SERVICE BULLETIN

Classification: EC17-028	Reference: NTB17-104	Date: September 14, 2017
-----------------------------	-------------------------	-----------------------------

2017 SENTRA; ENGINE TURNS OFF OR HESITATES WHEN ACCELERATING FROM A STOP DURING HOT AMBIENT TEMPERATURES (100° F OR MORE)

APPLIED VEHICLE: 2017 Sentra (B17)

Figure 2

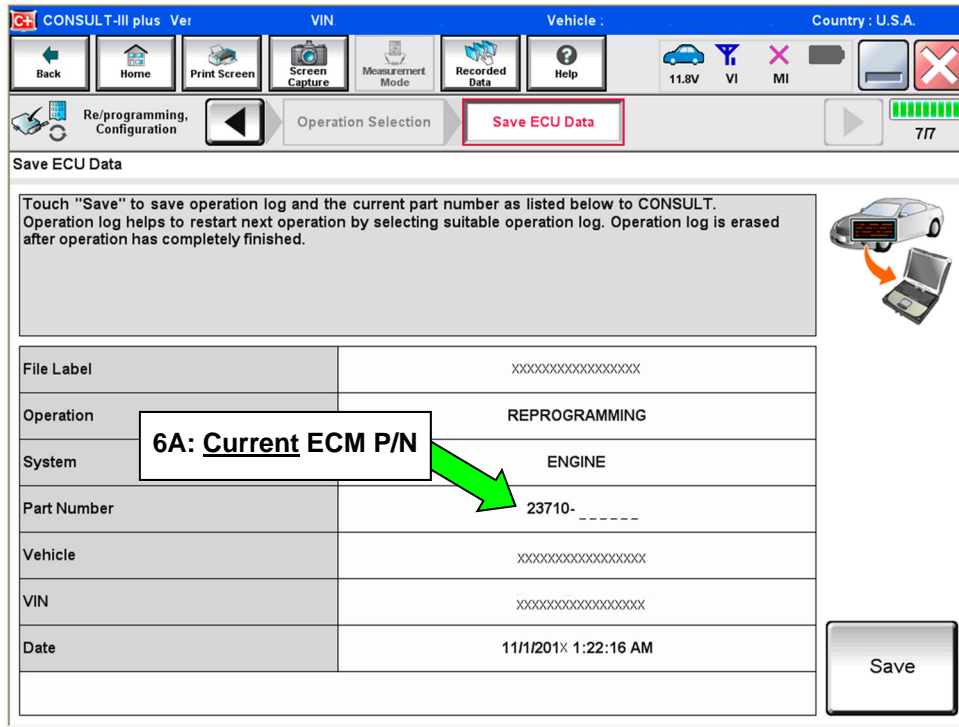
6. When you get to the screen shown in Figure 2, confirm this bulletin applies as follows.

A. Find the ECM **Part Number** and write it on the repair order.

B. Compare the P/N you wrote down to the numbers in the **Current ECM Part Number** column in **Table A** on below.

- If there is a match, continue with the reprogramming procedure.
- If there is not a match, reprogramming does not apply. Refer to ASIST for further diagnostic and repair information.

Figure 3

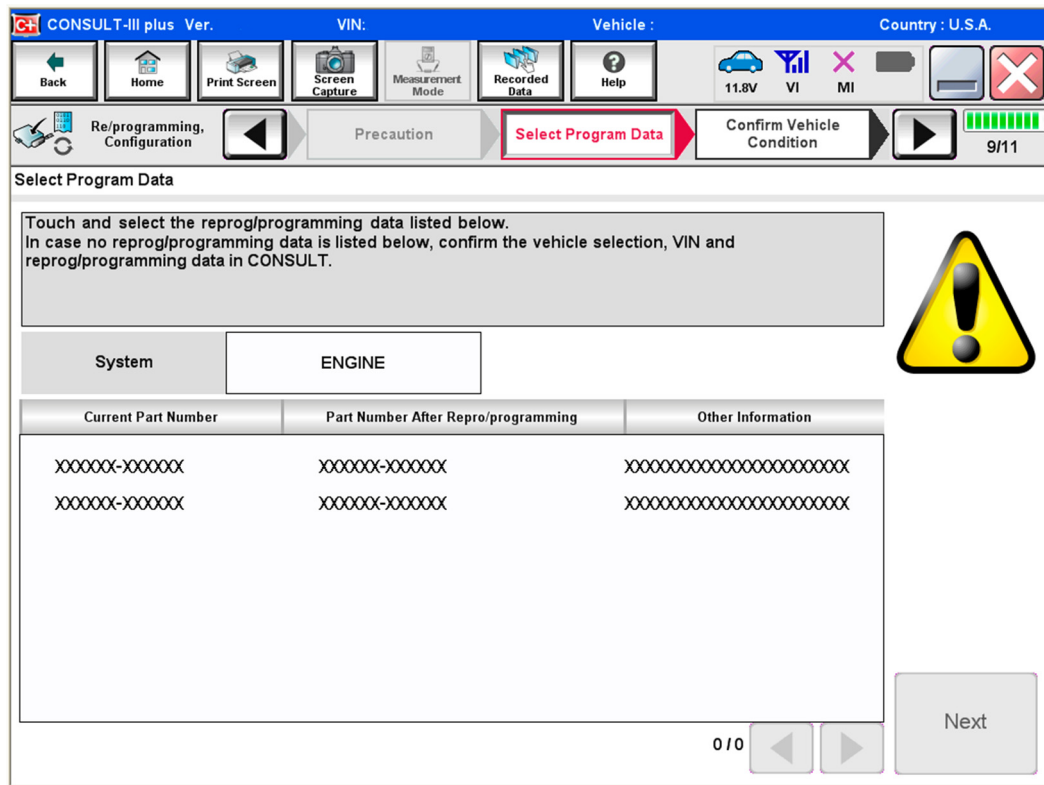
- In some cases, more than one new P/N for reprogramming is available.
 - If there is more than one new P/N, the screen in Figure 3 displays.
 - Select and use the reprogramming option that **does not** have the message “Caution! Use ONLY with NTBXX-XXX”.
- If you get this screen and it is blank (no reprogramming listed), it means there is no reprogramming available for this vehicle.

Figure 7

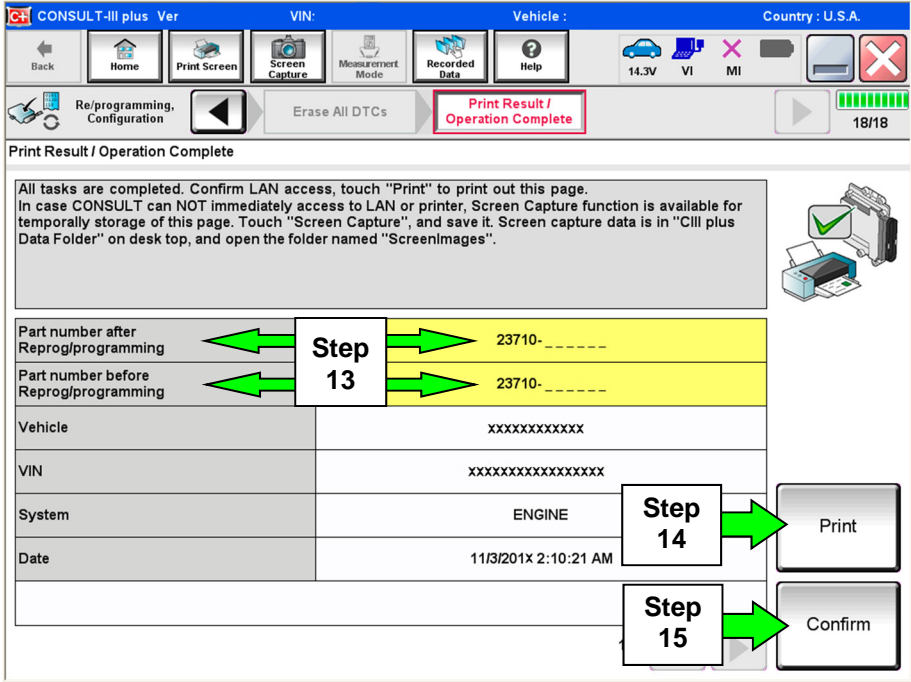
- 12. When the entire reprogramming process is complete, the screen in Figure 7 will display.
- 13. Verify the before and after part numbers are different.
- 14. Print a copy of this screen (Figure 7) and attach it to the repair order for warranty documentation.
- 15. Select **Confirm**.
